EEG-33  
DOE/AL/10752-33

## **ADEQUACY OF TRUPACT-I DESIGN FOR TRANSPORTING CONTACT-HANDLED TRANSURANIC WASTES TO WIPP**

Environmental Evaluation Group  
Environmental Improvement Division  
Health and Environment Department  
State of New Mexico  
P.O. Box 968  
Santa Fe, NM 87503

June 1986

Figure 2. TRUPACT-I transport package.

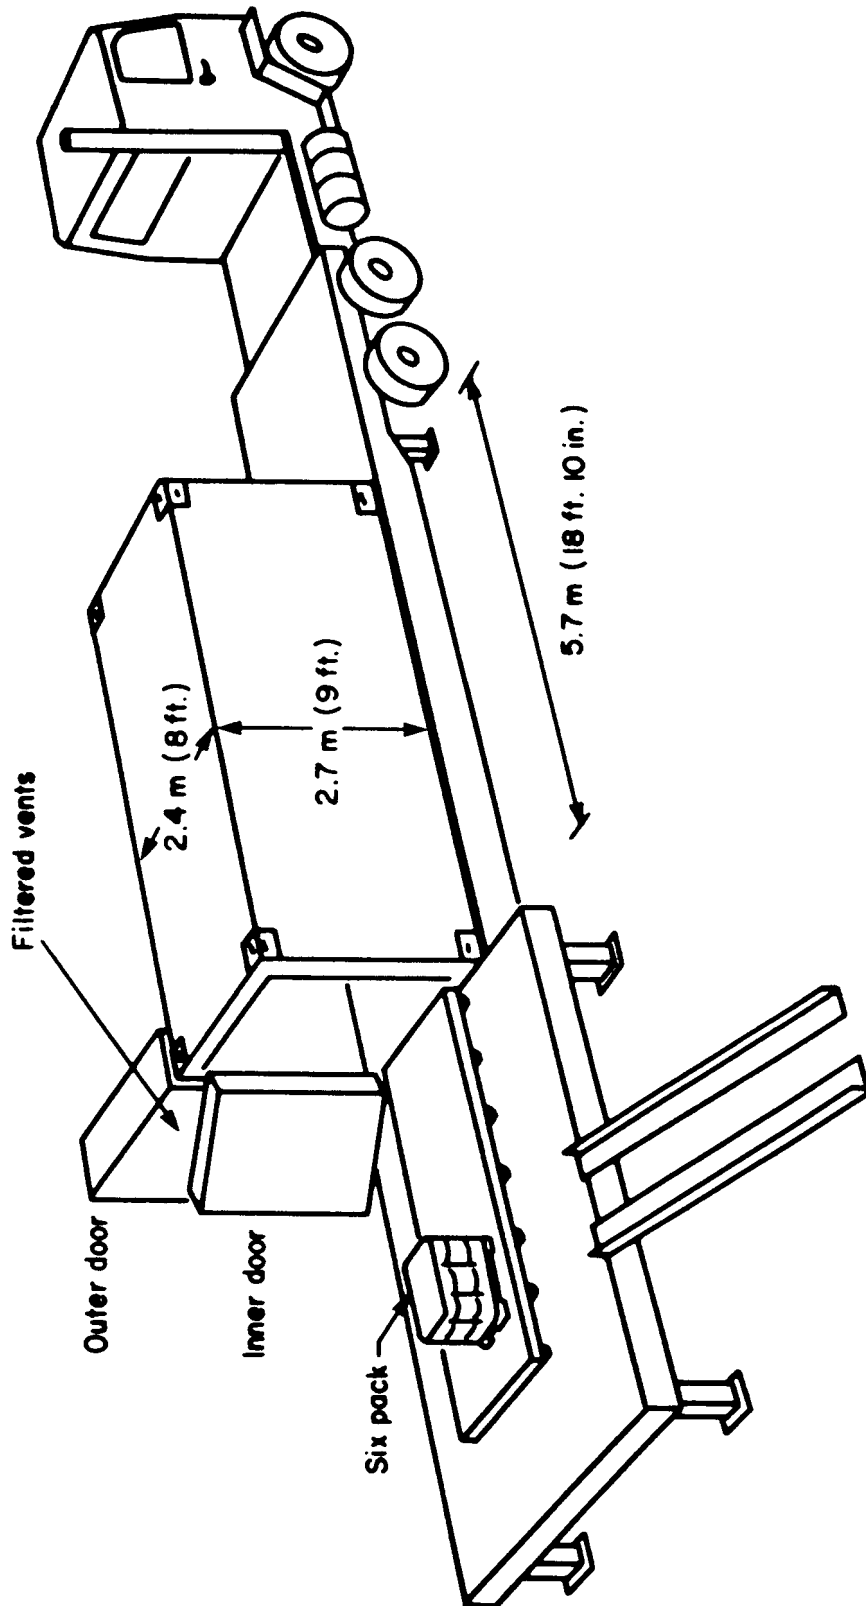
TRUPACT I was designed with two features that do not meet the NRC and DOT transportation regulations:

- (1) it has only single containment, which is not permitted for most forms of radioactive material if the shipment contains greater than 20 Curies of plutonium; and
- (2) the waste storage cavity is continuously vented through filters to the atmosphere.

The TRUPACT was designed in 1978 for single containment (Ref 5). Federal regulations in existence at that time, as well as today, required a double containment design (Ref 6 and 7) for shipments in excess of 20 curies of plutonium. Most of the shipments to WIPP will have more than 20 curies of plutonium.

EEG recommends that TRUPACT-I not be certified for transporting any waste to WIPP unless the vents are sealed and the package is limited to 20 curies of plutonium per load. We further recommend that: (1) the TRUPACT be redesigned to include double containment and eliminate continuous venting; (2) the use of methods other than venting for hydrogen gas control be seriously

considered; and (3) the maximum curie content in a TRUPACT be limited to approximately 2,000 curies.

Figure 10. Filter vent concepts.

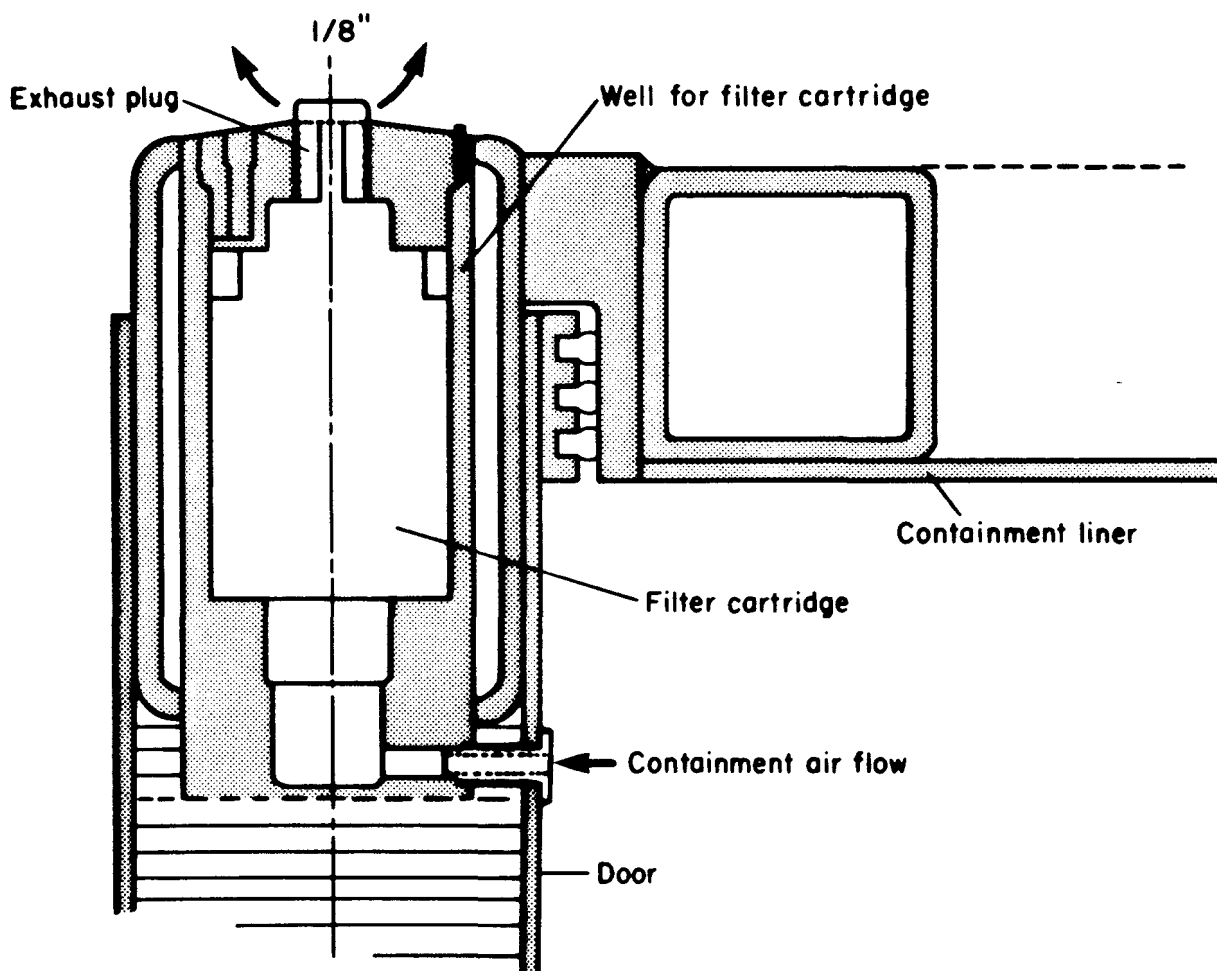
The third option, venting, has received the most attention by DOE. The concept which has been most thoroughly investigated involves venting the waste packages through rugged high efficiency filters or permeable gaskets and vent clips so that gases are released. Particulates are supposed to be retained in the containers even under severe transport conditions. Figure 10 (a) illustrates the small filter (RFP bung filter) being considered by DOE for Type A packages, and 10 (b) the filter design which has been proposed for the TRUPACT (if it is vented). The prime consideration is whether venting will provide the needed control of hydrogen concentrations in Type A packages and the Type B TRUPACT under the actual transport conditions of the waste forms and TRU concentrations anticipated

The experiments at RFP with actual drums of TRU waste have shown that venting with the RFP bung filter does limit the accumulation of hydrogen to levels below those found when the drums were sealed. On the basis of these experiments, then venting alone will maintain concentrations of hydrogen below 4% if the product of G ( $H_2$ ) and  $\alpha$ -curies is below about 40 (Ref 33). Unfortunately, as was noted in the RFP experiment, no drums were tested for hydrogen generation rates of 20 to 60  $\alpha$  CiG( $H_2$ ) to confirm their prediction.

Figure 14. Vented TRUPACT with 36 drums (20 Ci/drum).

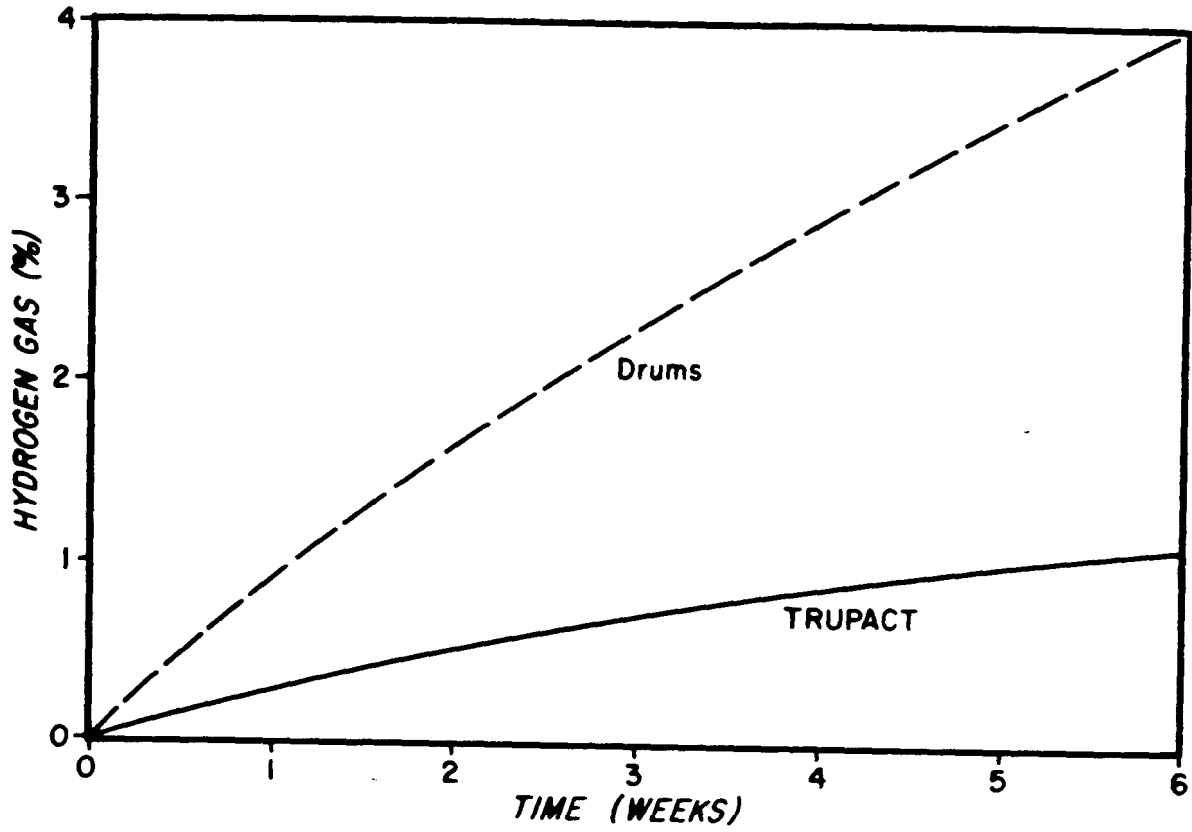
By modeling, we have attempted to examine the predicted efficacy of venting. If the case of dry combustibles where  $G$  (hydrogen) = 2.1 is extended to the maximum controllable loading by the Clements and Kudera method, the allowable loading would be 20 curies and the 4% limit would be exceeded in about 3 weeks. Furthermore, if 36 of these drums were loaded into a vented TRUPACT, concentrations would reach 4% hydrogen in 6 weeks. (See Figure 14).

Our perception of the venting process at this time is that during the initial post-closure period following purging, the relatively rapid buildup of hydrogen concentration either due to high initial  $G$ (hydrogen) or the presence of hydrogen in sealed packages diffusing into the void, or both, quickly displaces air from the void space without a large loss of hydrogen, since the initial hydrogen concentration gradients are small. But then as the hydrogen concentration builds, even though the hydrogen contributions from various sources may drop to modest levels, the hydrogen concentration can rise to the flammable or explosive limit if the curie level is high enough. A critical factor in the process just outlined is the occurrence of an initial high influx of hydrogen, even for a few hours or days.

results, we conclude that venting of the Type A and Type B (TRUPACT) waste packages to achieve hydrogen control is not likely to result in the desired effect for a significant portion of the present defense TRU inventory and thus should not be relied upon as a control mechanism, particularly if a relatively inexpensive and effective alternative control practice is available.
